**Re: Townhomes-Rio Rancho Housing Development
99999 Golf Course NW (Golf Course & Westside)
Conceptual Traffic Circulation Layout for DFT Approval
Engineer's Stamp no date (A12D008E) TRANS-2025-00215**

TRAFFIC CONTROL LAYOUT PLAN

Sheet Number:
TCL02

B1 Bike Rack Detail
1/2"=1'-0"

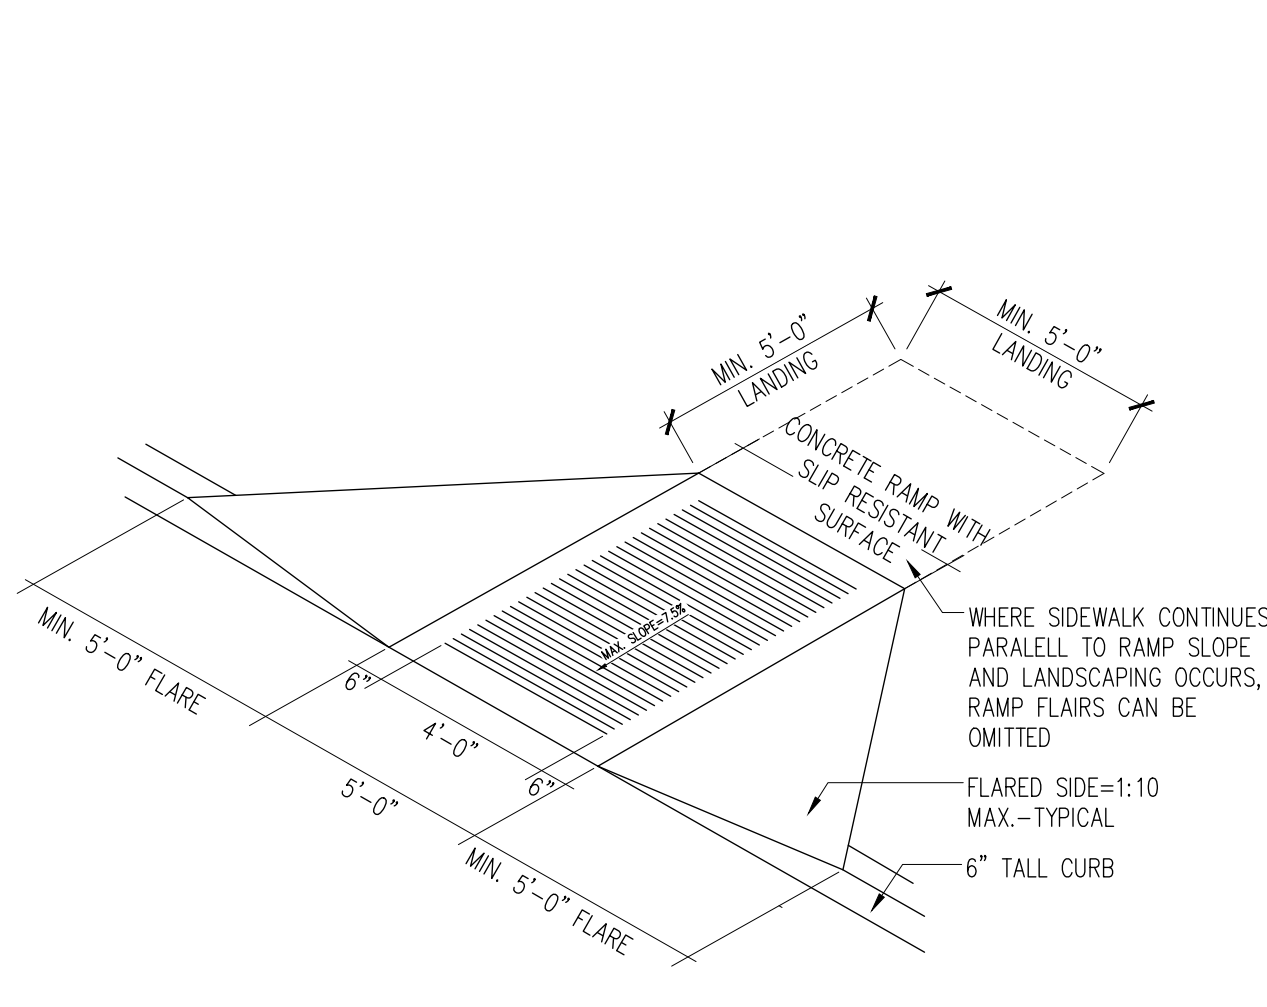
- 1-A 6 ft sidewalk, and 5-6 ft Landscape/Buffer along Westside & Golf Course are required and shown on the TCL plan**
- 2- A 5 ft sidewalk, and 4-6 ft Landscape/Buffer along all private road are required and shown on the TCL plan**
- 3-on Detail B1 add all missing dimensions**
- 4-on Detail A2 change the HC parking space to 8.5 ft.**
- 5-on Detail A4 change 8 to 8.5 ft.**
